SAFENIGHT TECHNOLOGY INC.

Re: Distributor Inspection Controls V. 2

SafeNight Technology Meeting
Friday, November 3, 1995
8:30am, Room T-8C1

Figure 1

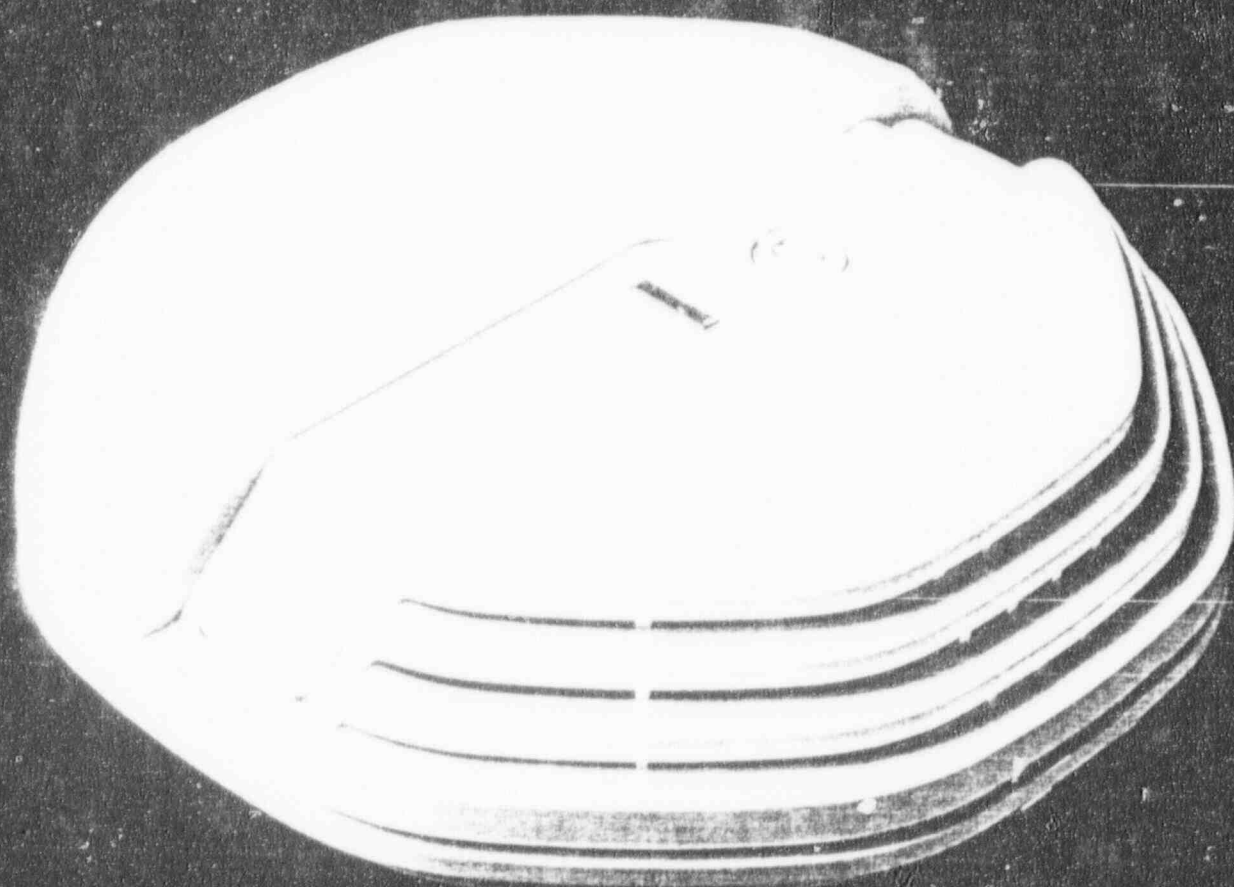
source holder - material?
(button)

AL, brass, SS?

need exact dim of source cup
VS. button
NRC & Amersham

drugs do not match 100 chamber cover

W/11 this is
a check of source
but the box/holder?
